and Management Parameters for 10 Mb/s Operation and Associated Power Delivery over a Single Balance

Cl 00 SC 0 P L # i-287

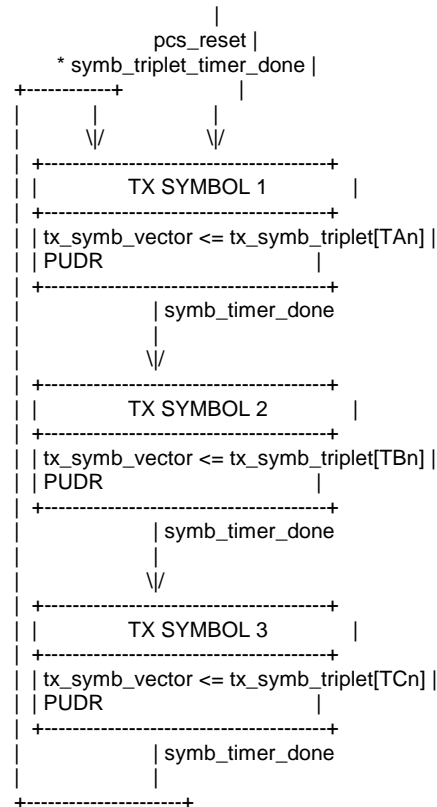
I think the problem is that there is another function within the PCS Transmit function that is missing from the PCS Transmit state diagram in Figure 146-5, the 'multiplexor' shown in Figure 146-6 'PCS transmit symbol generation'. This 'multiplexor' function operates at the symbol clock rate and serialises the tx_symb_triplet code-groups output by the PCS Transmit state diagram into individual symbols.

[6] Insert a new Figure 145-6 shown below (view using a non-proportional font such as courier), renumbering the following figures as required.

[4] Add a new subclause 146.3.3.2.2 titled 'Timers'. Move the symb_timer definition from subclause 146.3.3.1.3 Timers to this new subclause.

[7] Add text to subclause 146.3.3 'PCS Transmit' that reads 'The PCS Transmit function shall conform to the PCS Transmit state diagram in in Figure 146-5 and the PCS Transmit multiplexor state diagram in 146-6, and their associated state variables, functions, timers, and messages.'
